**SC0372**

## Steering Shaft Pinch Bolts Loose

CXU, GU

**Vehicles with Intermediate shaft only:**

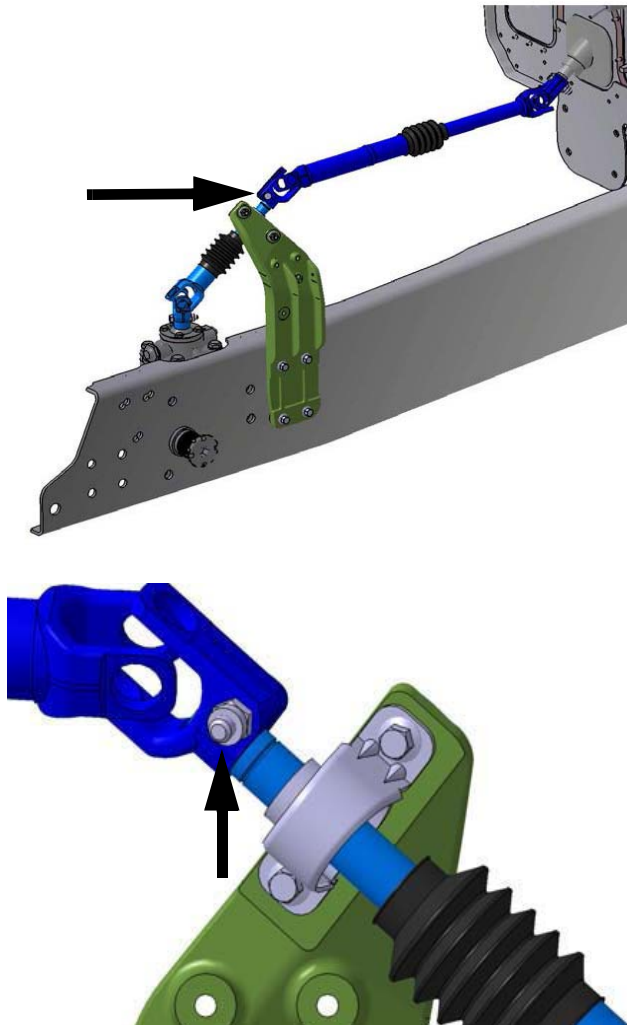
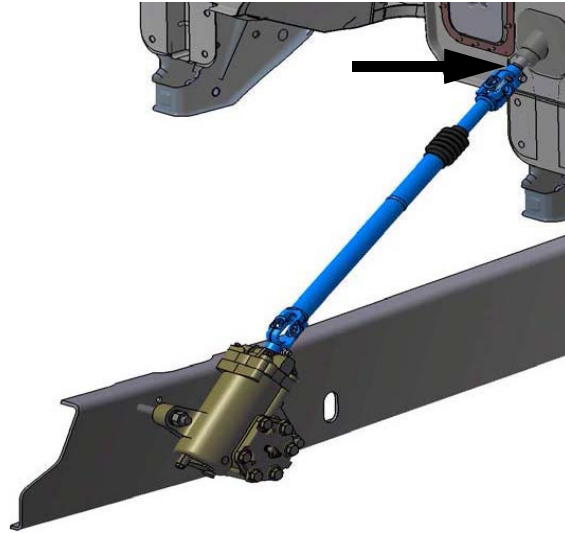
5. Remove the pinch bolt to the center steering shaft.
6. Install the new center pinch bolt and nut and secure. Torque to 95 +/- 7 Nm (70 +/- 5 ft-lb).

7. Remove the pinch bolt to the upper steering shaft.
8. Install the new upper shaft pinch bolt and nut and secure. Torque to 95 +/- 7 Nm (70 +/- 5 ft-lb).
9. Close the hood.
10. Connect the batteries.
